Access Compliance Report

Public Rights-of-Way

Intersection ID: 24455	Main Street: S_TRYON_ST	Cross Street: STEELE_CREEK_RD	Location: SW
ADA ID: 8EA8A51443B0	Ramp Type: Perpendicular	Initial Pass/Fail: Fail	Overall Compliance: No
		Severity Score: 12.5

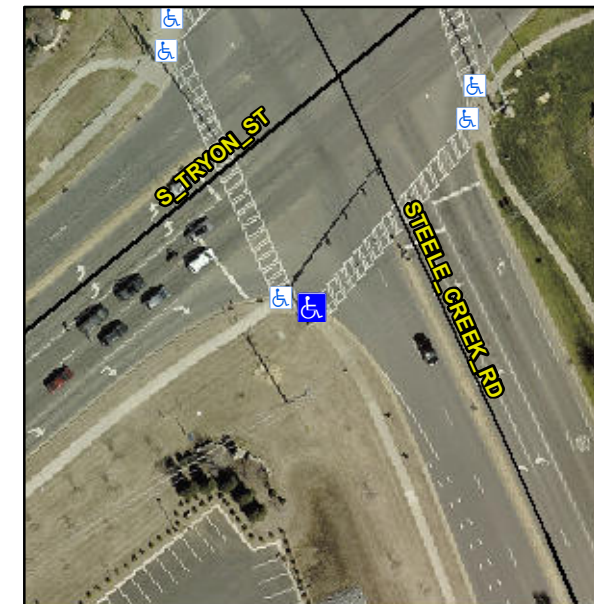
R304.2.2

Compliance	Description	Data	Compliance	Description	Data
N/A	Ramp Length (in)	68.0	No	Ramp Slope (%)	9.1
Yes	Ramp Width (in)	48.0	Yes	Ramp XSlope (%)	0.6
N/A	Flare Type LT	N/A	N/A	Flare Type RT	N/A
N/A	Flare Slope LT (%)	N/A	N/A	Flare Slope RT (%)	N/A
N/A	Flare Traversable LT?	N/A	N/A	Flare Traversable RT?	N/A
N/A	Landing Length (in)	N/A	N/A	DWS Provided?	N/A
N/A	Landing Width (in)	N/A	N/A	DWS Contrast?	N/A
N/A	Landing Slope (%)	N/A	N/A	DWS Length (in)	N/A
N/A	Landing X Slope (%)	N/A	N/A	DWS Full Width?	N/A
N/A	Landing Curb? (Y/N)	N/A	N/A	DWS Offset (in)	N/A
N/A	Shared Landing?	N/A			
N/A	Gutter Ponding?	N/A	N/A	Gutter Slope (%)	N/A
N/A	Gutter Lip Ht (in)	N/A	N/A	Gutter X Slope (%)	N/A
N/A	Painted X Walk1?	Yes	N/A	Painted X Walk2?	N/A
	X Walk 1 Direction	To NE		X Walk 2 Direction	N/A
N/A	X Walk 1 Width (in)	120.0	N/A	X Walk 2 Width (in)	N/A
	X Walk 1 Slope (%)	2.5		X Walk 2 Slope (%)	N/A
	X Walk 1 X Slope (%)	1.1		X Walk 2 X Slope (%)	N/A

Remove & Replace Entire Ramp.
